ECE/TRANS/180/Add.2/Corr.1

### **Global technical regulation No. 2**

### Erratum

MEASUREMENT PROCEDURE FOR TWO-WHEELED MOTORCYCLES EQUIPPED  
WITH A POSITIVE OR COMPRESSION IGNITION ENGINE WITH REGARD TO THE  
EMISSION OF GASEOUS POLLUTANTS, CO<sub>2</sub> EMISSIONS AND FUEL CONSUMPTION

Figure 6-1: vehicle classification

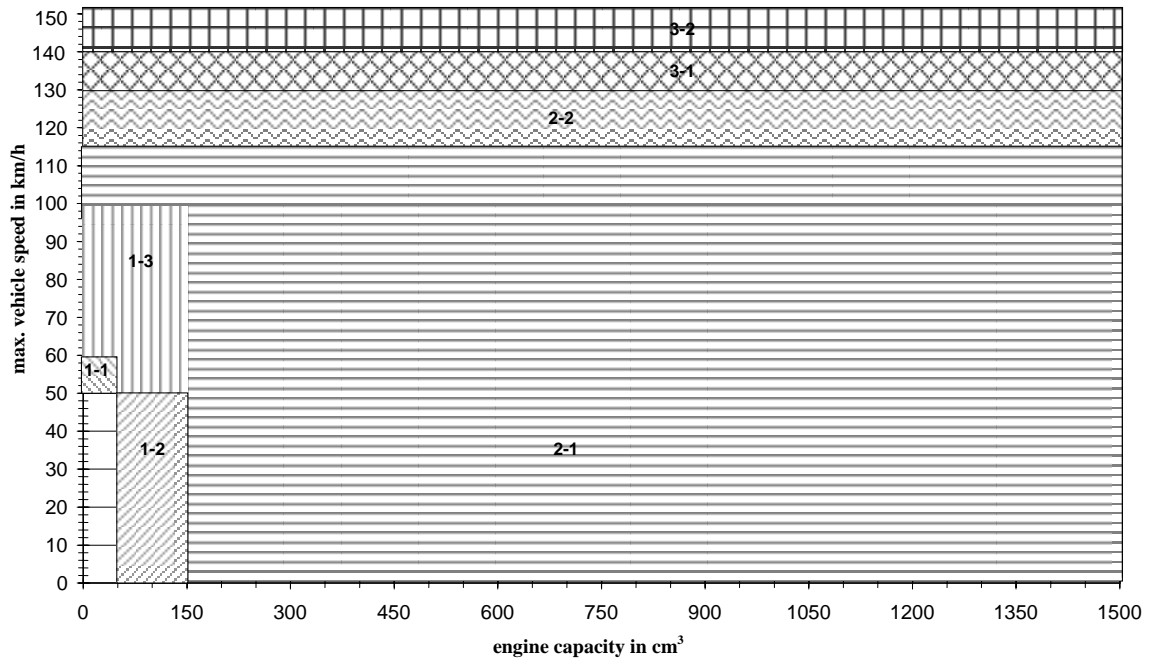
Page 14, paragraph 6.3.3.

For the existing figure 6-1 substitute
